**ZONING AND PLATTING COMMISSION
SITE PLAN VARIANCE REQUEST REVIEW SHEET**

CASE: SP-2013-0441D

PROJECT NAME: 3961 Westlake Drive

The applicant proposes to construct a pedestrian incline elevator for shoreline access to an existing boat dock.

Existing shoreline access

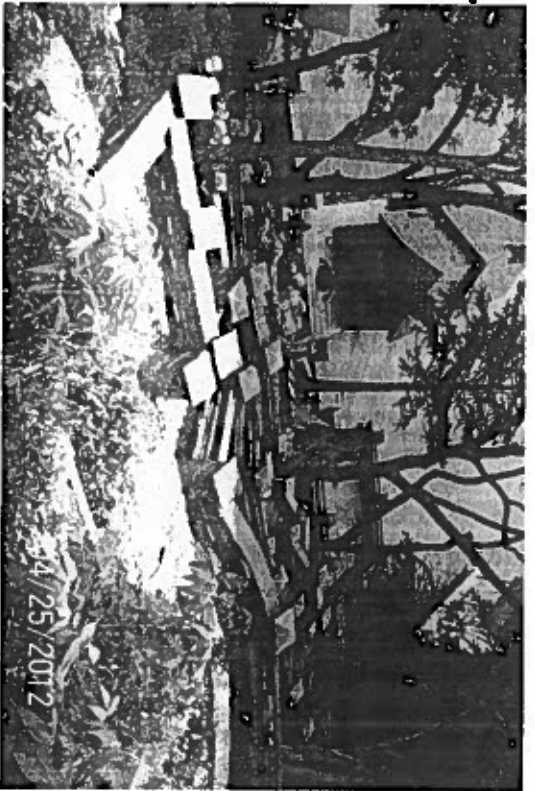
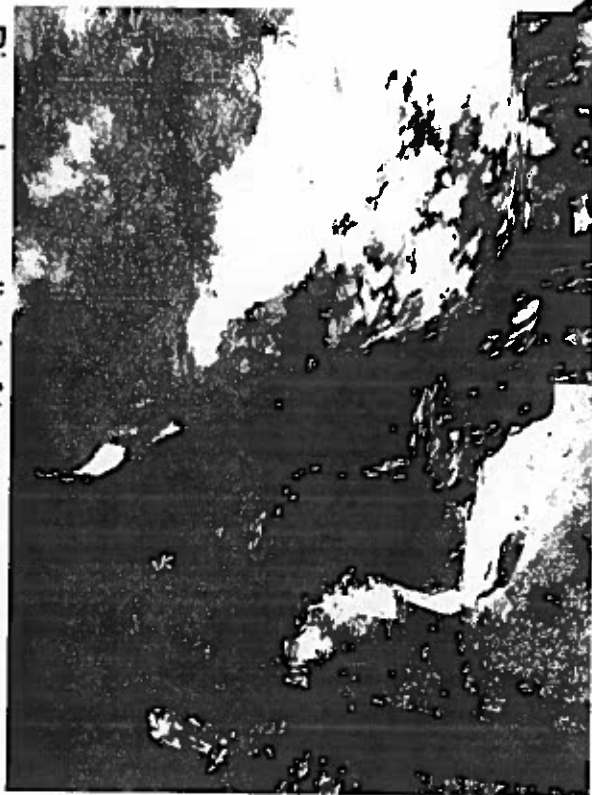
No. Shoreline access in the form of stairs has existed on this property for decades with shoreline access in the form of stairs. New stone steps were constructed for the boat dock that was recently permitted in 2011.

No. The applicant could choose to remove the existing steps used for shoreline access and restore and revegetate the disturbed area within the Critical Water Quality Zone. This restoration would eliminate the need for a CWQZ variance entirely.

Rimrock upgradient of tram

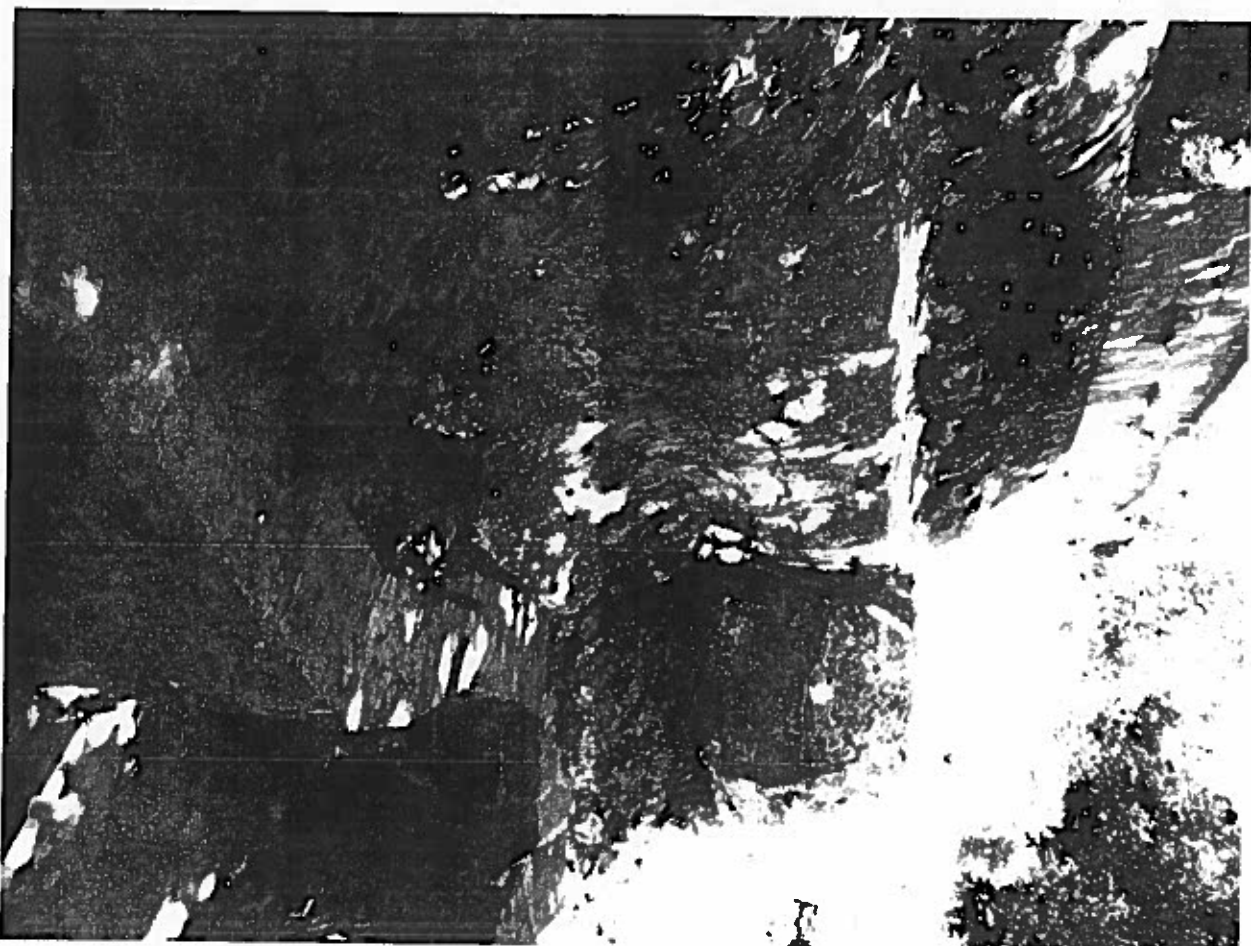
No. The applicant could choose to remove the existing shoreline access stairs, restore and revegetate the disturbed area within the canyon rimrock Critical Environmental Feature (CEF) buffer, and therefore minimize disturbance downslope of the CEF.
